**Lee Nuclear Station Units 1 and 2  
Description, Scope of Changes, and FSAR Impacts due to Plant Relocation and  
Additional Design Enhancements**

**Description and Rationale for Lee Nuclear Station Units 1 and 2 Relocation and  
Additional Design Enhancements**

FIGURE 2.4.3-234

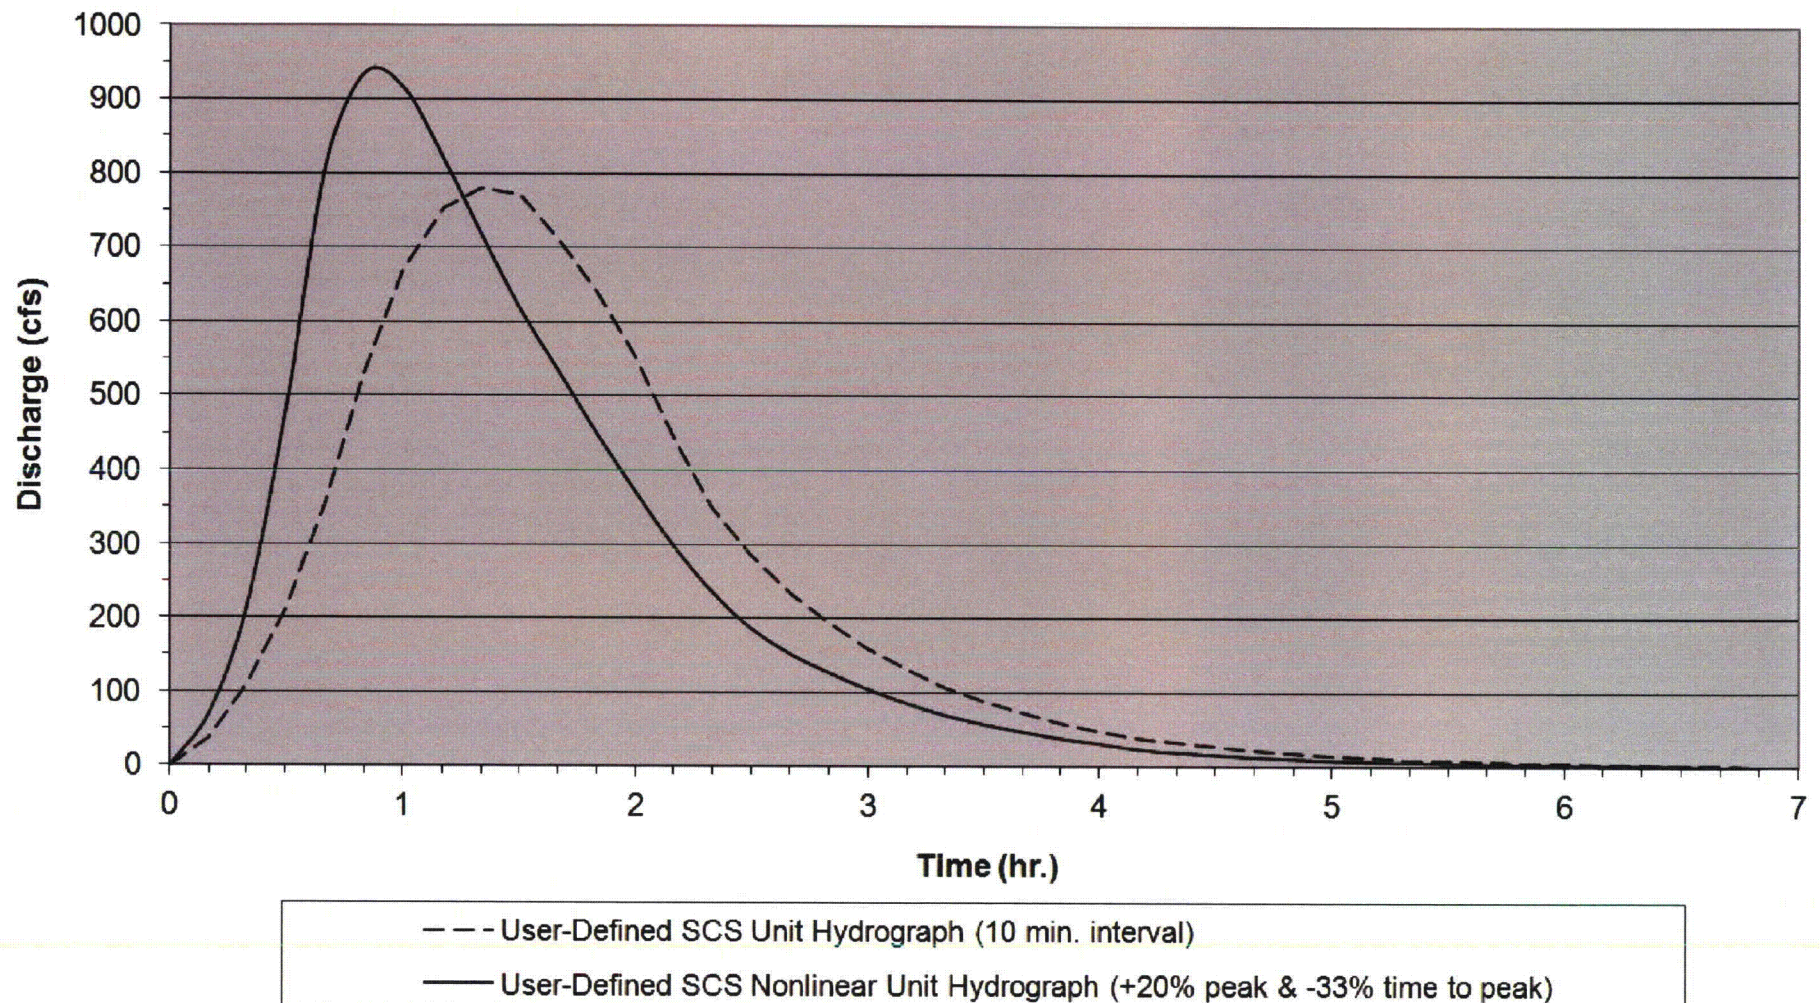
Wind wave activity on Make-Up Pond B is evaluated coincident with the maximum water surface elevation of the PMF including the effects of dam failure, as discussed above. The determined critical fetch length of 4.471.39 mi. is shown in Figure 2.4.3-234. The 2-year annual extreme mile wind speed is adjusted based on the factors of fetch length, level overland or over water, critical duration, and stability. The critical duration is approximately 35 min. The adjusted wind speed is 50.33 mph.

54. COLA Part 2, FSAR Chapter 2, Figure 2.4.3-234 is revised as follows:

FIGURE 2.4.3-237

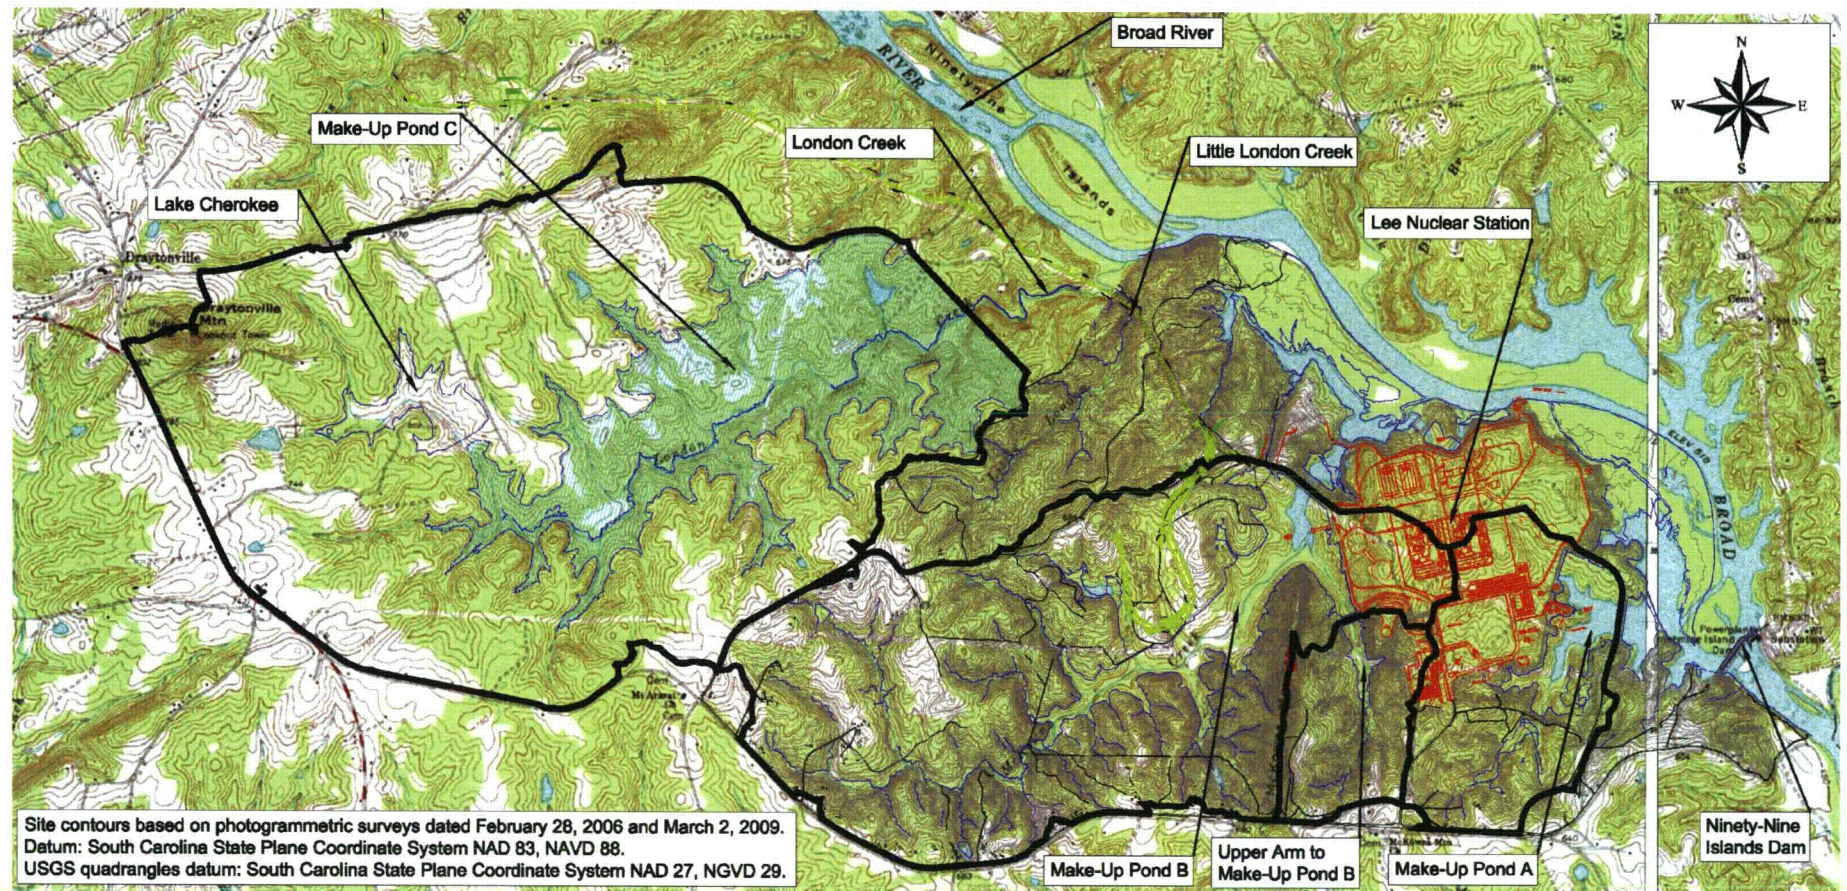
The best calibration of the modified SCS unit hydrograph with the initial SCS unit hydrograph was found using a 10-min. computational time step in Make-Up Pond B in the HEC-HMS modeling software. Therefore, the time step used to define the ordinates of the modified SCS unit hydrograph is also 10 min. The Make-Up Pond B subbasin has a lag time of ~~77~~76.8 min. The initial SCS unit hydrograph and modified unit hydrograph to account for the effects of nonlinear basin response are provided in Figure 2.4.3-237. The modified SCS unit hydrograph is tabulated in Table 2.4.3-208.

55. COLA Part 2, FSAR Chapter 2, Figure 2.4.3-237 is revised as follows:

FIGURE 2.4.3-239

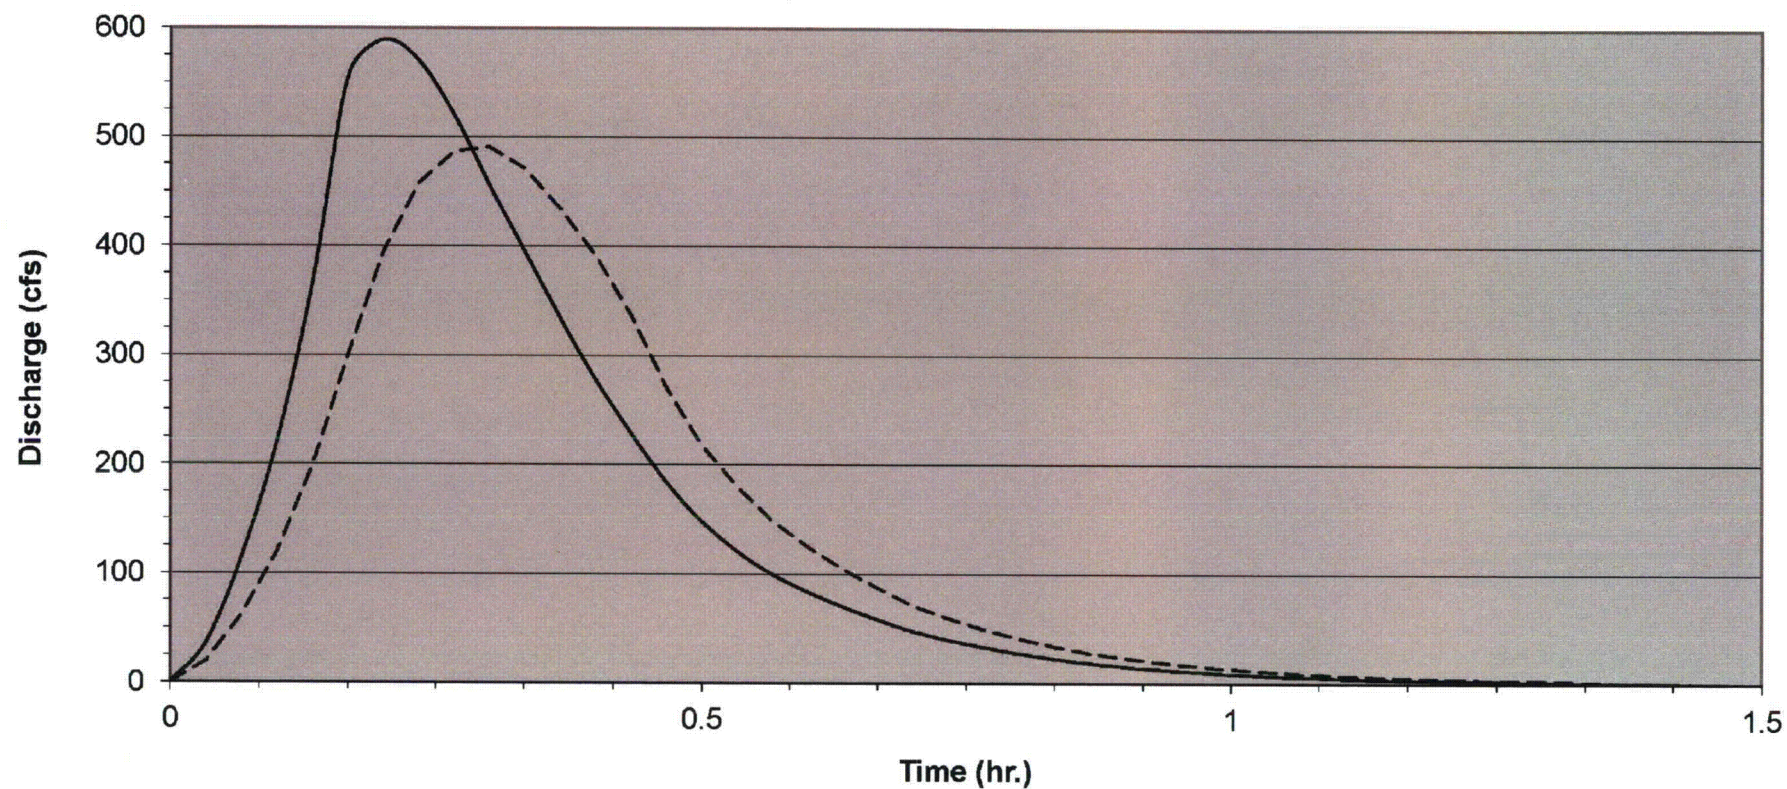
56. COLA Part 2, FSAR Chapter 2, Figure 2.4.3-239 is revised as follows:

FIGURE 2.4.3-246

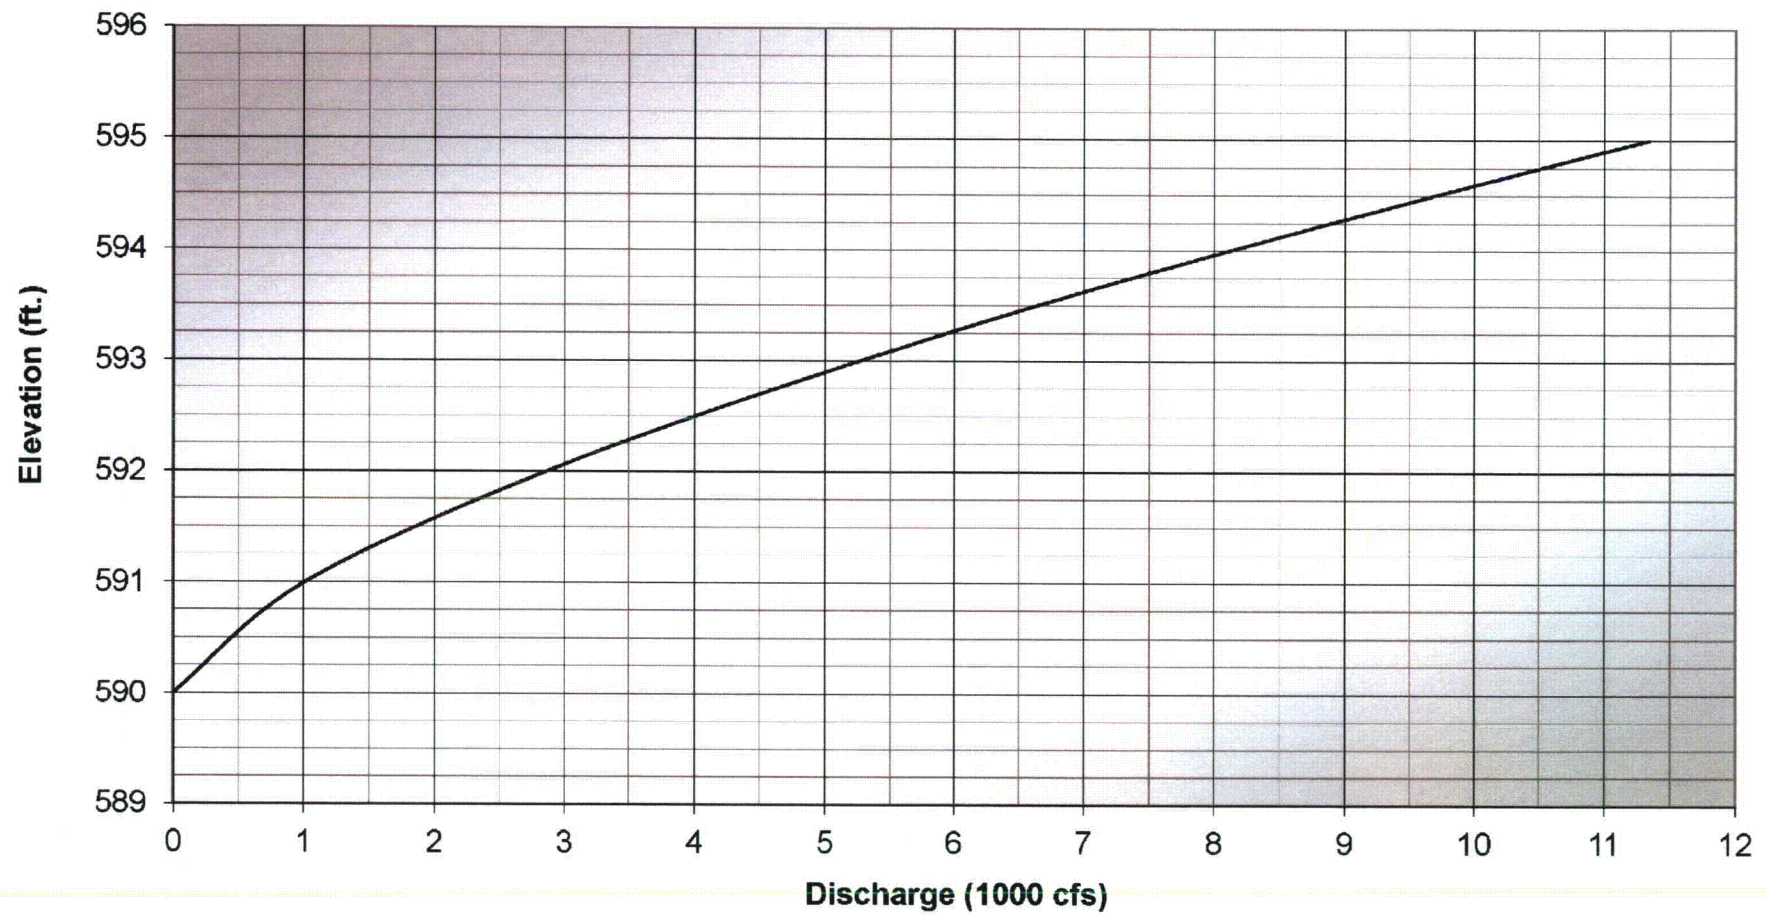
The best calibration of the modified SCS unit hydrograph with the initial SCS unit hydrograph was found using a 2-min. computational time step in the Upper Arm watershed in the HEC-HMS modeling software. Therefore, the time step used to define the ordinates of the modified SCS unit hydrograph is also 2 min. The Upper Arm subbasin has a lag time of ~~46~~16.2 min. The initial SCS unit hydrograph and modified unit hydrograph to account for the effects of nonlinear basin response are provided in Figure 2.4.3-246. The modified SCS unit hydrograph is tabulated in Table 2.4.3-209.

57. COLA Part 2, FSAR Chapter 2, Figure 2.4.3-246 is revised as follows:

FIGURE 2.4.3-247

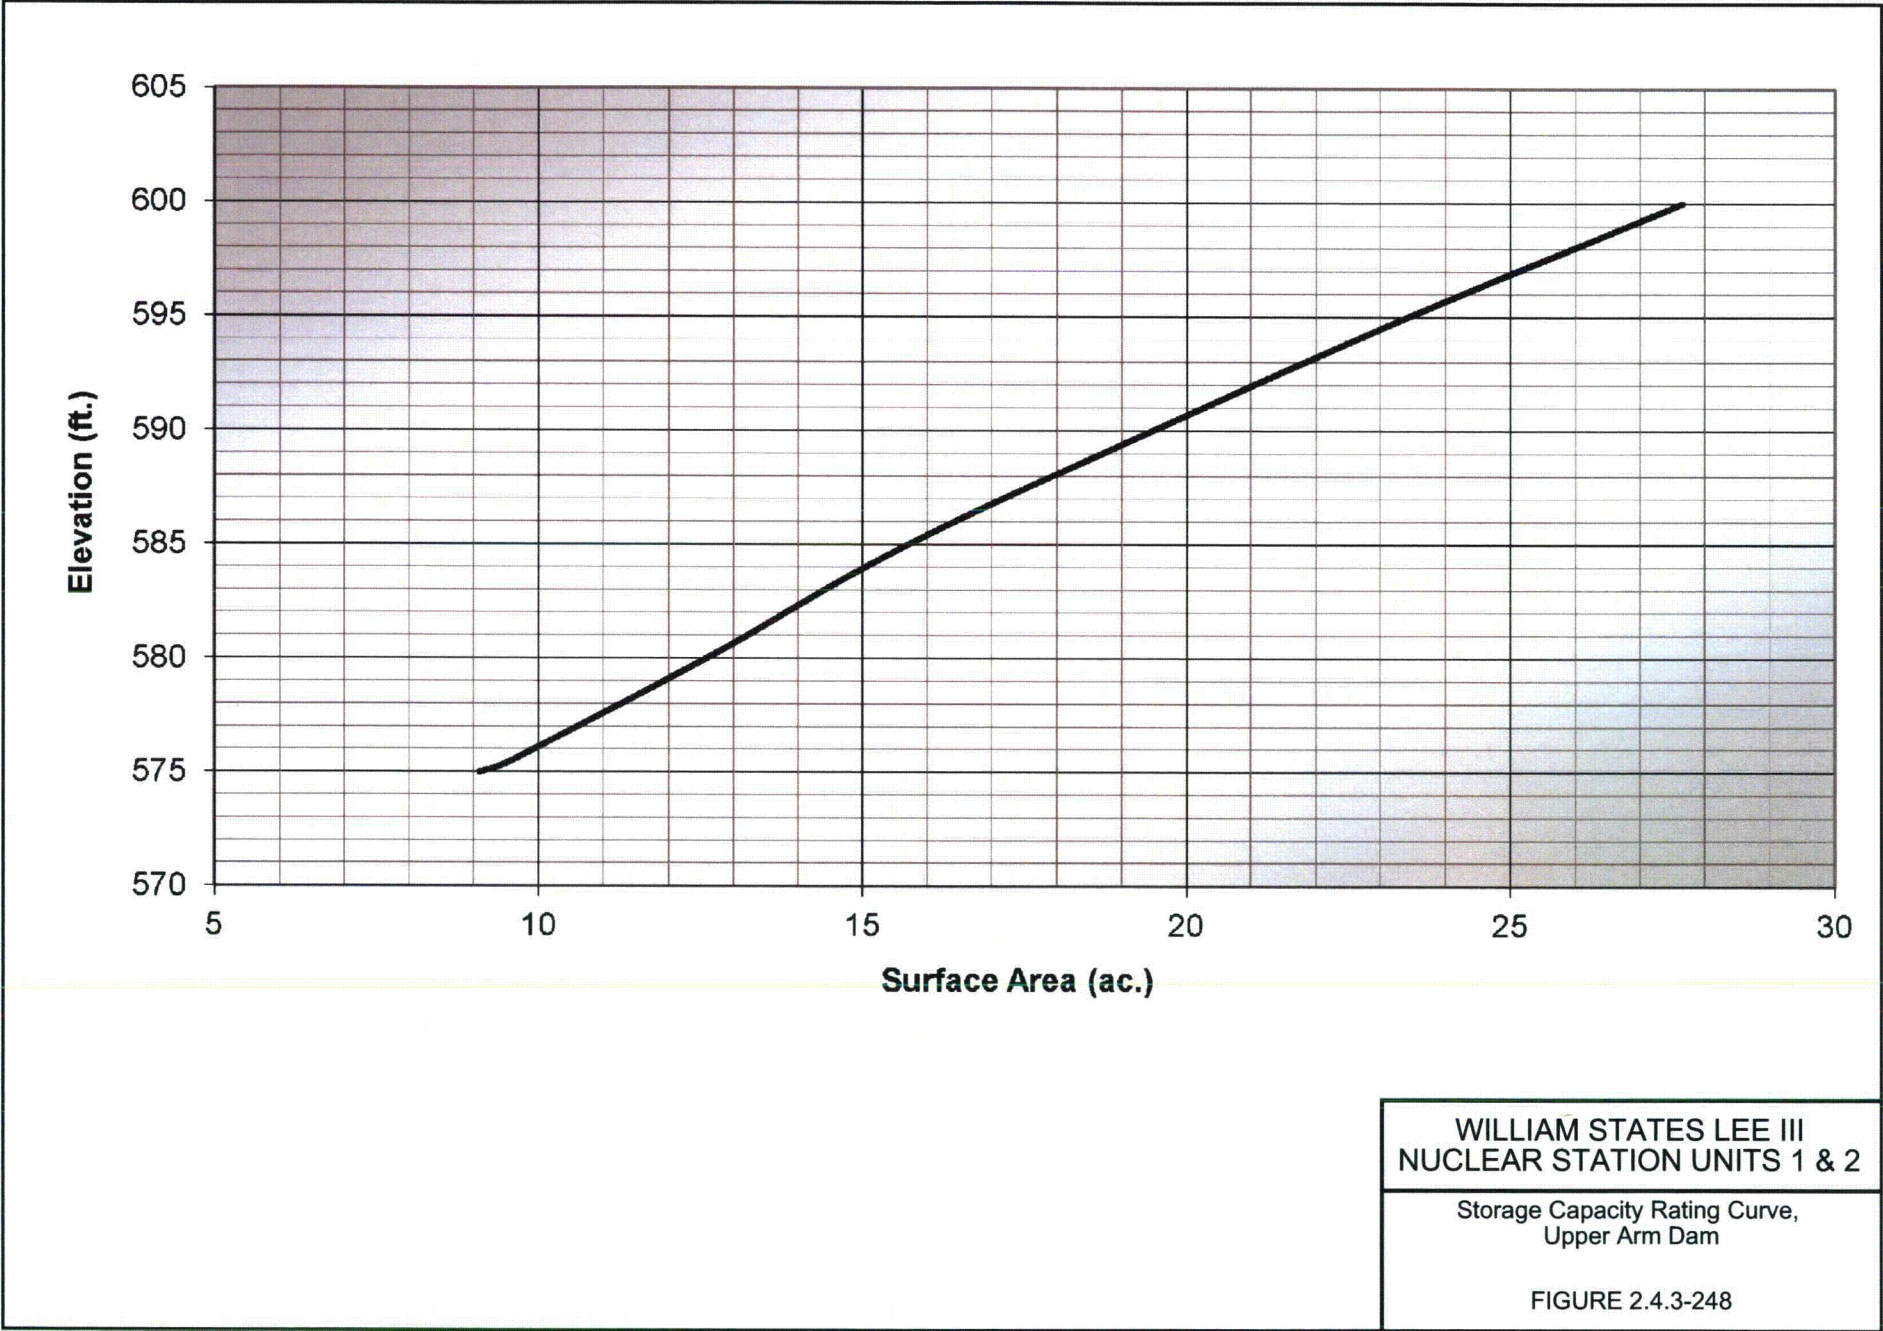
58. COLA Part 2, FSAR Chapter 2, Figure 2.4.3-247 is revised as follows:

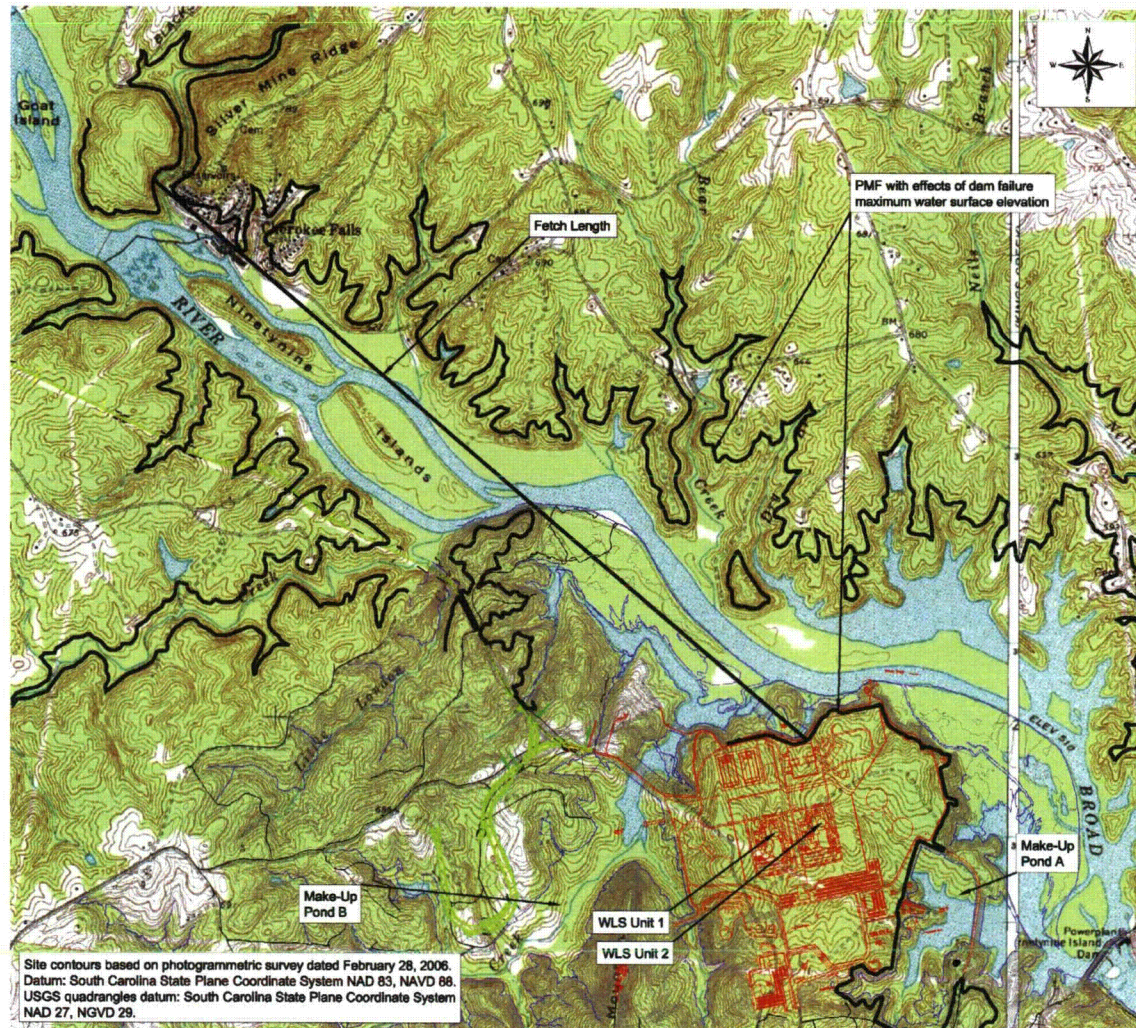
59. COLA Part 2, FSAR Chapter 2, Figure 2.4.3-248 is revised as follows:
